Re: Geotechnical Engineering Report Addendum 3  
Summit Square II Apartments - Pavements  
NW Ward Road and NW Donovan Road  
Lee's Summit, Missouri  
Terracon Project Number: 02185057.03

**Geotechnical Engineering Report Addendum 3**

Summit Square II Apartments - Pavements ■ Lee's Summit, Missouri  
September 12, 2018 ■ Terracon Project No. 02185057.03

**Alternative 1 Pavement Section  
Light-Duty**

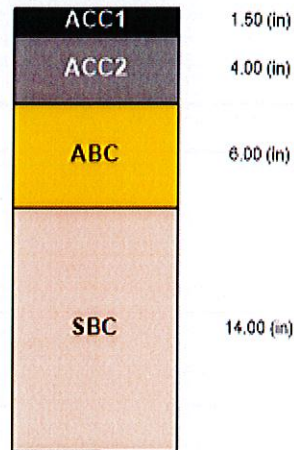
equivalent section by replacing the stabilized subgrade or geogrid with additional MoDOT Type 5 aggregate. Alternative 2 is designed to provide an equivalent section by replacing the stabilized subgrade or geogrid with the existing gravel-soil mixture on site. Terracon has estimated a layer coefficient for the soil-gravel mixture of 0.050. This coefficient has been conservatively estimated as less than half of MoDOT Type 5 coefficient (0.120) and less than a fly ash stabilized subgrade layer coefficient (0.080). The following table provides the layer coefficients for the equivalent alternative sections.

Subgrade Modulus = 5,000 (psi)  
Structural Number = 3.440  
Calculated Traffic (ESALs) = 291,000

**Alternative 2 Pavement Section  
Light-Duty**

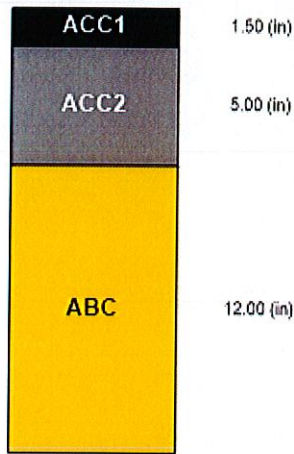
Subgrade Modulus = 5,000 (psi)  
Structural Number = 3.420  
Calculated Traffic (ESALs) = 280,000

UDO Pavement Section	Alternative 1	Alternative 2
1.5 inches ACC surface	1.5 inches ACC surface	1.5 inches ACC surface
4 inches ACC base	4 inches ACC base	4 inches ACC base
6 inches granular base with geogrid – OR –	12 inches MoDOT Type 5 aggregate	6 inches MoDOT Type 5 aggregate
6 inches granular base course with 6 inches stabilized subgrade		14 inches compacted subgrade (gravel-soil mixture)

**Alternative 1 Pavement Section  
 Heavy-Duty**

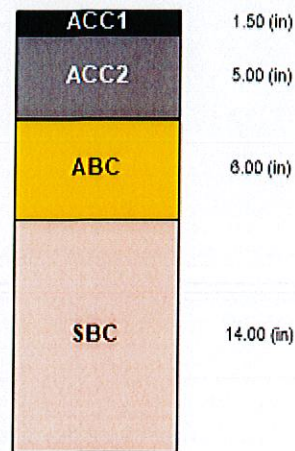
Subgrade Modulus = 5,000 (psi)  
 Structural Number = 3.790  
 Calculated Traffic (ESALs) = 563,000

UDO Pavement Section	Alternative 1	Alternative 2
1.5 inches ACC surface	1.5 inches ACC surface	1.5 inches ACC surface
5 inches ACC base	5 inches ACC base	5 inches ACC base
6 inches granular base with geogrid – OR –	12 inches MoDOT Type 5 aggregate	6 inches MoDOT Type 5 aggregate
6 inches granular base course with		14 inches compacted subgrade (gravel-soil mixture)
6 inches stabilized subgrade
